APPLICANT: Westinghouse Electric Corporation  
PROJECT: AP600  
SUBJECT: SUMMARY OF AP600 MEETING TO DISCUSS AP600 STRUCTURAL  
MODULES

The purpose of the meeting was to review structural calculations in order to resolve final safety evaluation report (FSER) open items that were sent to Westinghouse in a December 9, 1997, letter. Attachment 3 provides the details of the results of the review for the selected FSER open items.

NRC Structural Meeting - 1/20 - 21/98  
FSER Open Items related to Structural Modules

Figure 3H.5-5 (Sheet 2 of 3)

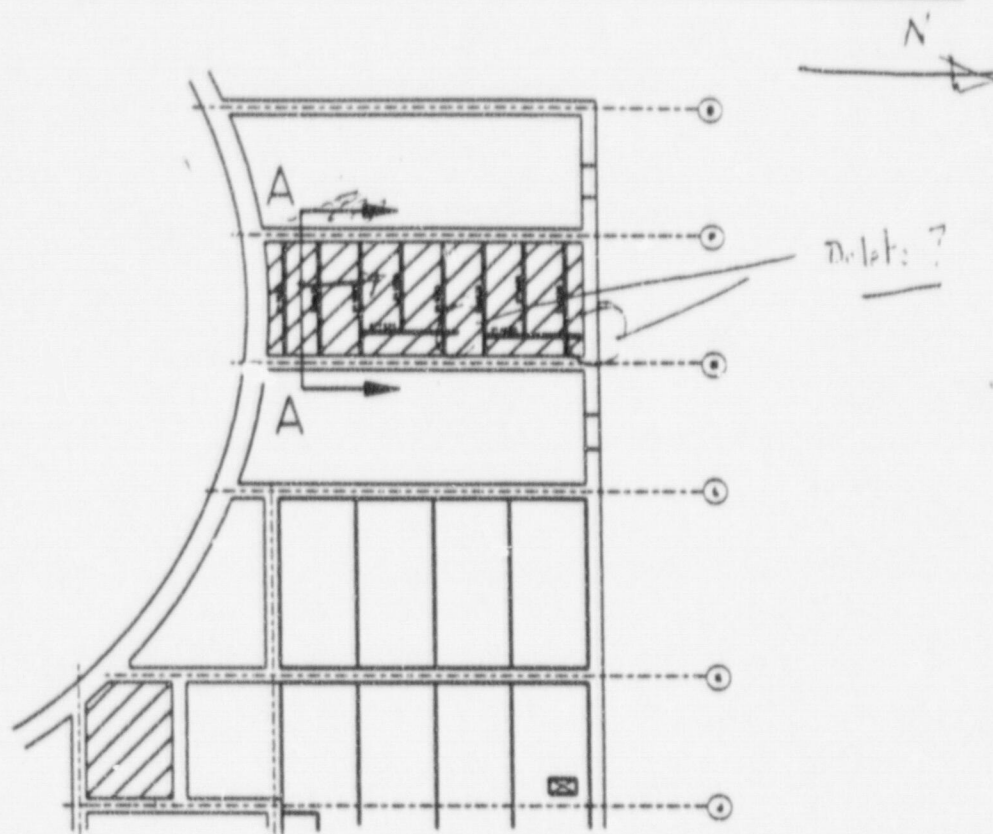
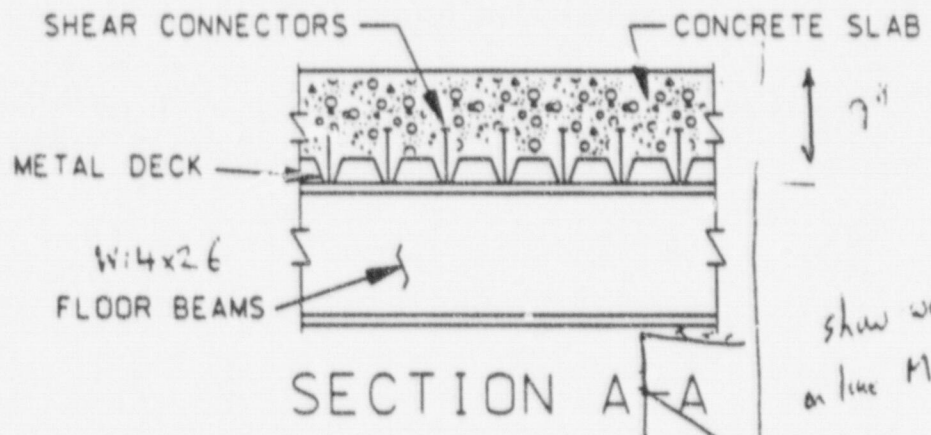
show end detail. Figure 3H.5-6

Figure 3H.5-7 (Sheet 1 of 2)

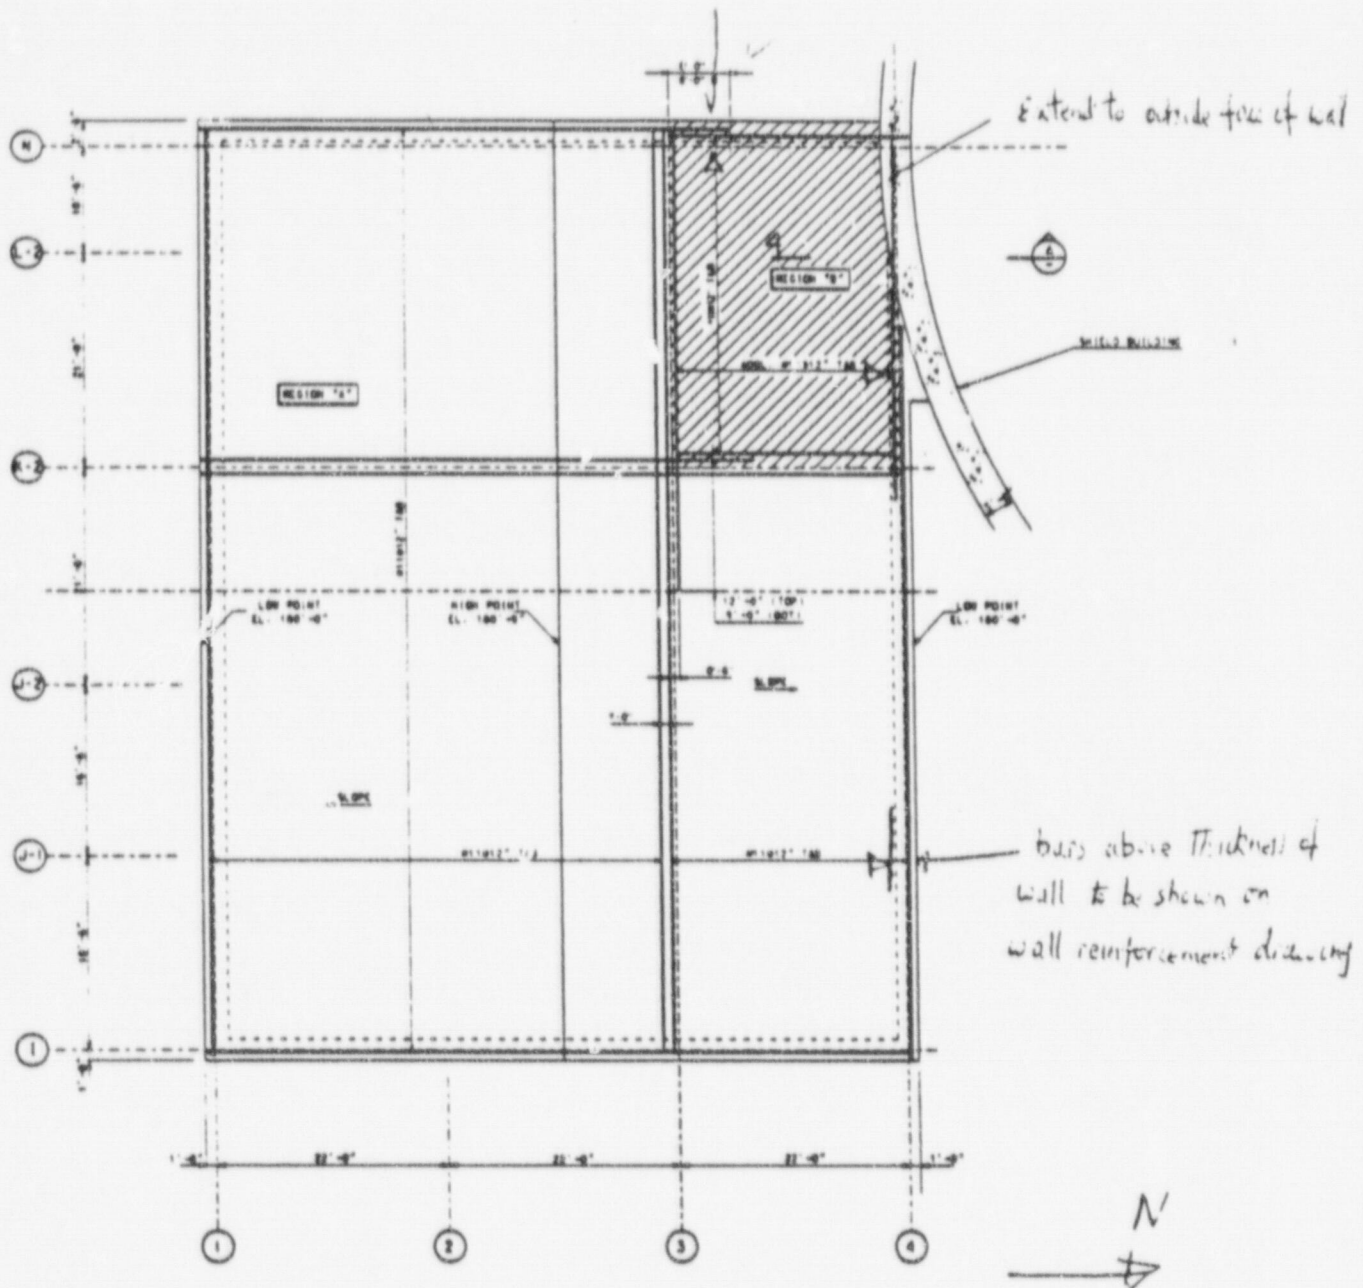
bars above thickness of wall to be shown on wall reinforcement drawing

Add new sheet showing reinforcement in walls just below the roof.

Figure 3H.5-7 (Sheet 2 of 2)

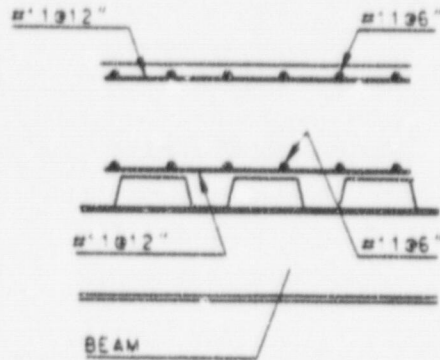
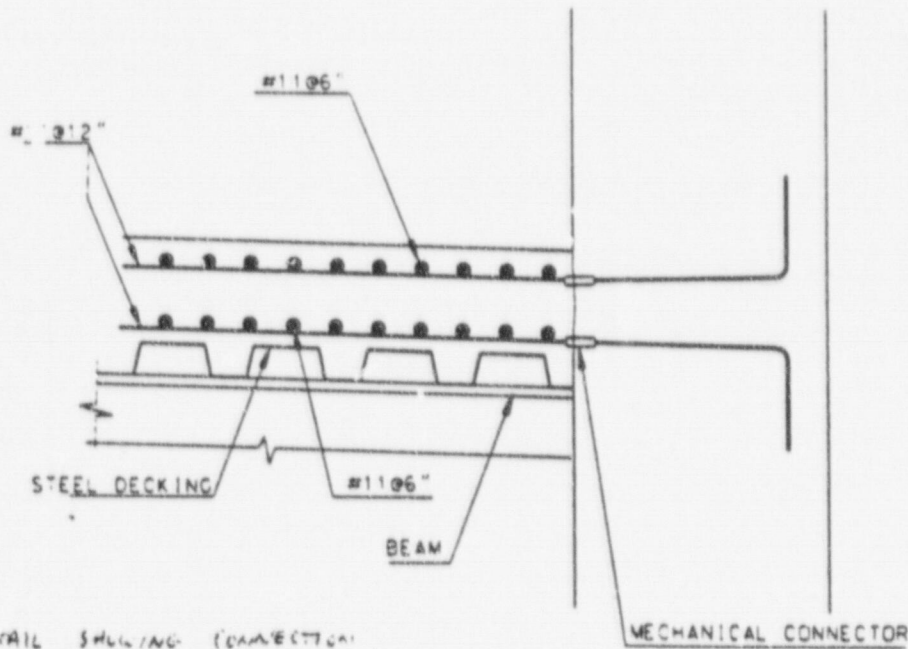
ADD DETAIL SHOWING CONNECTION  
OF STEEL GIRDER
